Re: 1376 Campus Road

Final Subdivision and Land Development Plan - Phase 4

Township Permit No. 25-06-FLDP

LCEC Project No: 25-100

SHEET NO.: 29 OF 42 NOT FOR BUILDING/NOT FOR CONSTRUCTION

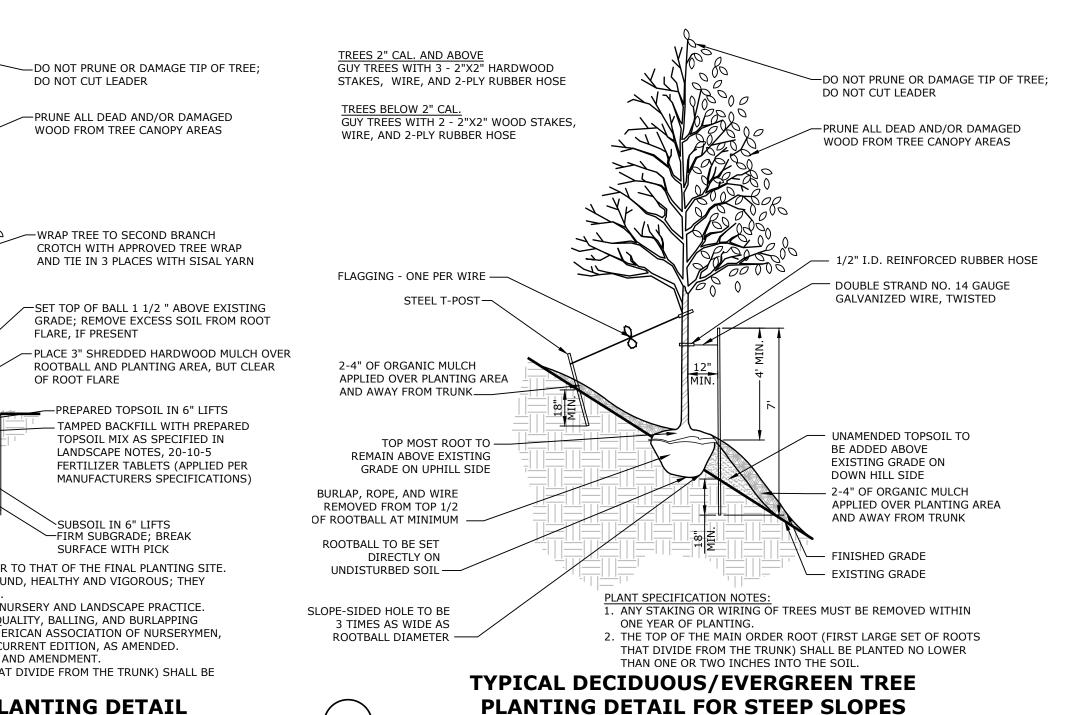
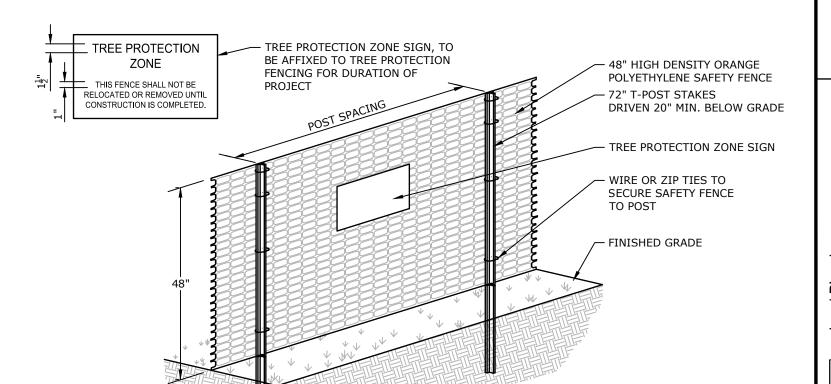
- 16. The landscape plan shall include information for the proposed plugs within BMP-012 (113-31.N and 113-37-A.(4)(d)).
- 17. Swale 21 shall be added to the Vegetated Channel detail (113-37.C(1)(d)).
- 18. A label for Swale 21 shall be provided on the plans (113-37.C(5)).
- 19. Swale 13 and Swale 14A shall be evaluated for stability based upon an "n" value equal to 0.03 (113-37.C.(5)(c)[1][a]).
- 20. The sum of the individual depths of the #57 stone, pea gravel, and diameter of the pipe shown in the Underdrain Section Detail and Cleanout With Pea Gravel Window construction details is inconsistent with the depth of amended soils (21") (113-43.J(5)). The 21" soil media depth shown in this detail is also inconsistent with the 18" amended soil depths shown elsewhere.

# Provide plug planting information
